Re: Petition No. 1583; Petition Of TRITEC Americas, LLC For A Declaratory Ruling That No Certificate Of Environmental Compatibility And Public Need Is Required For The Construction, Operation, Maintenance, And Decommissioning Of A 0.999 MW AC Solar Photovoltaic Project In Bethany, Connecticut – Responses to the Council's Pre-Hearing Interrogatories (First Set).

Petition No. 1583
TRITEC Americas, LLC
Parcel Nos. 113-1 and 113-1-A
428 Bethmour Road, Bethany, Connecticut
Pre-Hearing Interrogatories to TRITEC
September 5, 2023

PRE-HEARING INTERROGATORIES - FIRST SET

SITE LAYOUT PLAN

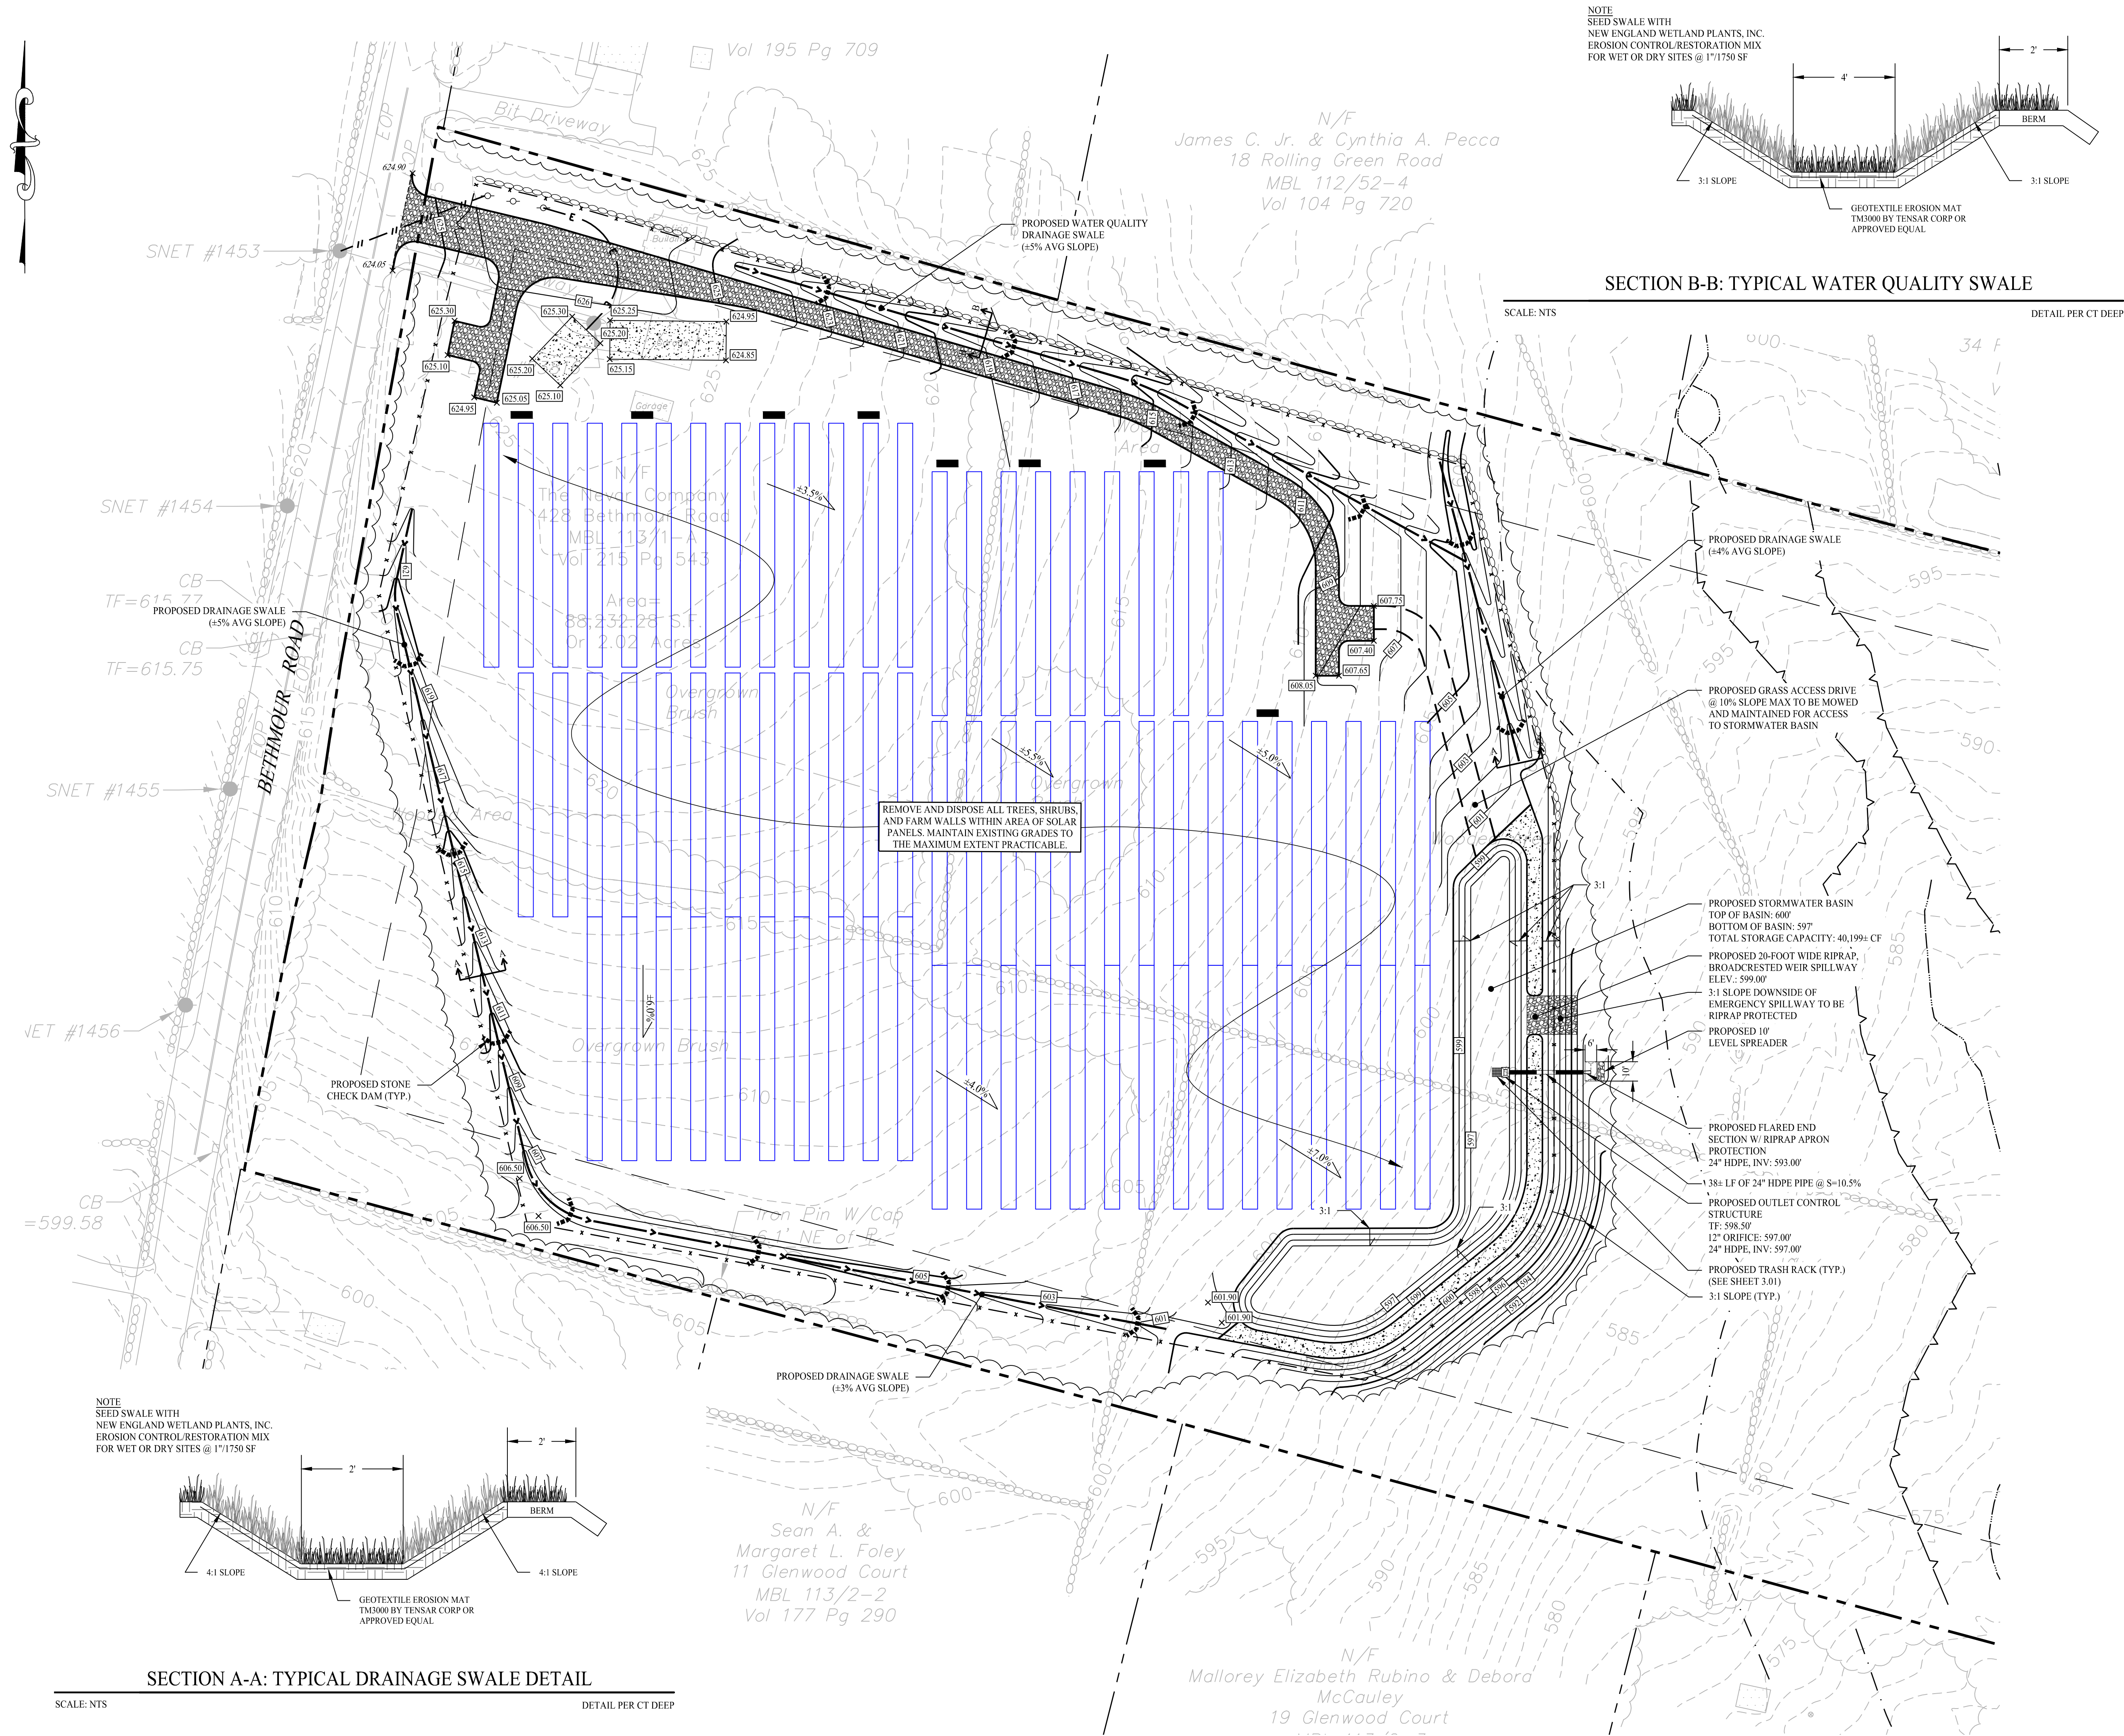
29. Petition Exhibit E Site Plan 2.11 provides the vegetated aisle width. How does the aisle width comply with the Soil Array Spacing Detail on Site Plan 3.01, given that slopes within the array attain 9.5 percent?

48. Provide a site plan that clearly shows the limit of tree removal and site grubbing.

50. What type of evergreen species are planned to be planted?

Per the detail on Sheet 3.01 in Attachment A, the proposed vegetated aisle width, or “disconnection length” shall be equal to or greater than the solar panel width. As shown on Sheet 2.11, the width of the solar panels is $\pm 7.8'$, while the proposed vegetated aisle width is $10'$.

Sheet 2.11 in Attachment A has been revised to show the proposed limits of tree clearing and site grubbing.

Seed mix notes have been added to Sheet 2.11 in Attachment A. ERNMX-147 will be used for final stabilization within the solar array. ERNMX-610 will be used outside the fence line and in non-array areas. New England Erosion Control/Restoration No Mow Mix will be used in the stormwater basin.

A total of (89) evergreen trees will be planted along the fence line. Per the Planting Schedule on Sheet 2.11 in Attachment A, those species are classified as American Arborvitae, White Fir, White Spruce & Colorado Blue Spruce. These trees will have an installed height of 7-8 feet and a mature height of 20 feet.

The existing stone walls within the perimeter fence will be affected by the development. It is the intent of the Petitioner to rebuild these stone walls outside the perimeter fence. See Sheet 2.11 in Attachment A for additional information.

7' HIGH CHAIN LINK FENCE DETAIL

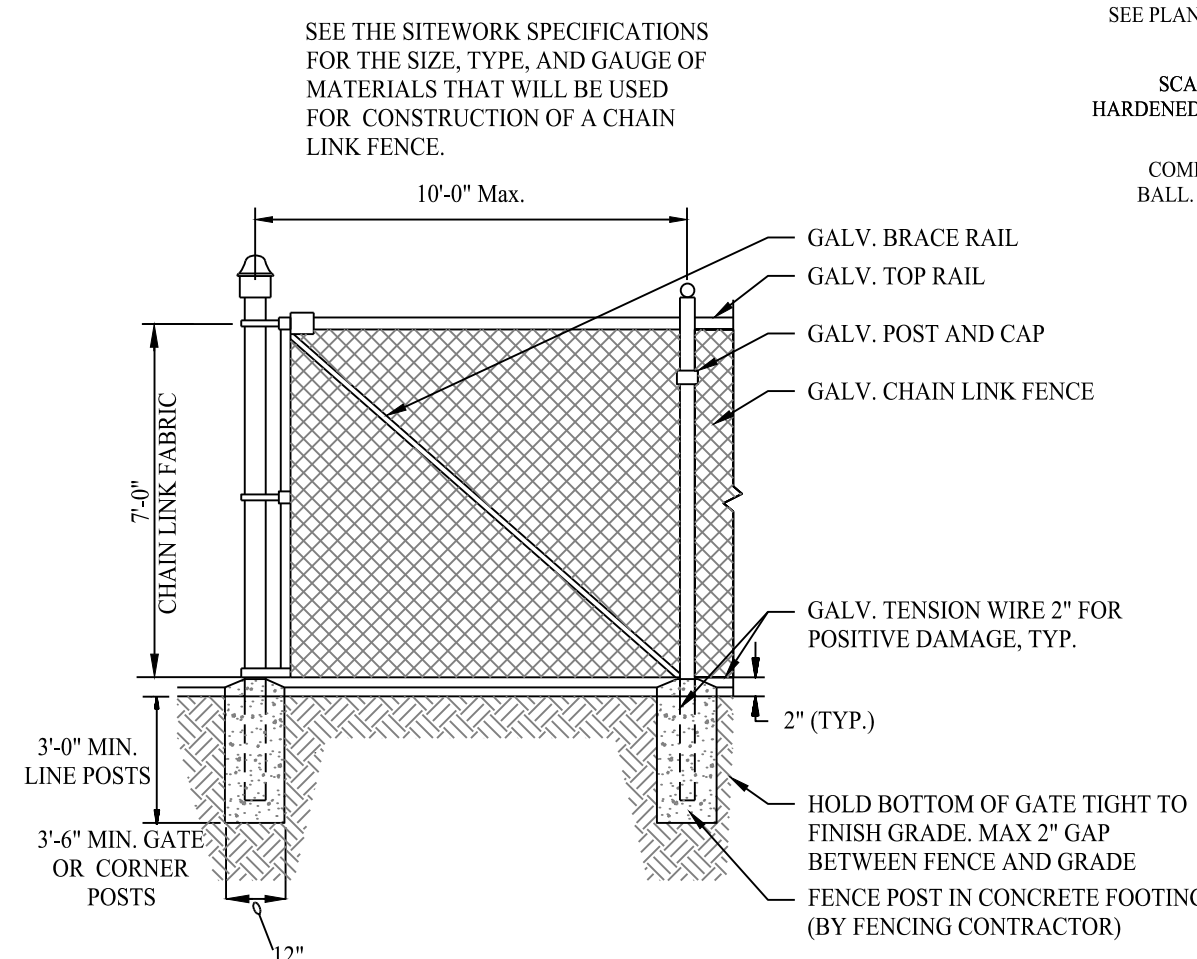
28. The Petition Exhibit E site plans specify a six-foot high fence, whereas the Exhibit L Site Plans specify a 7-foot fence. Both plan sets have the same date. Which set of plans is correct?

The correct fence height is 7'. All site plans and exhibits have been revised to reflect the correct fence height and are attached. See Attachment B: Environmental Assessment.
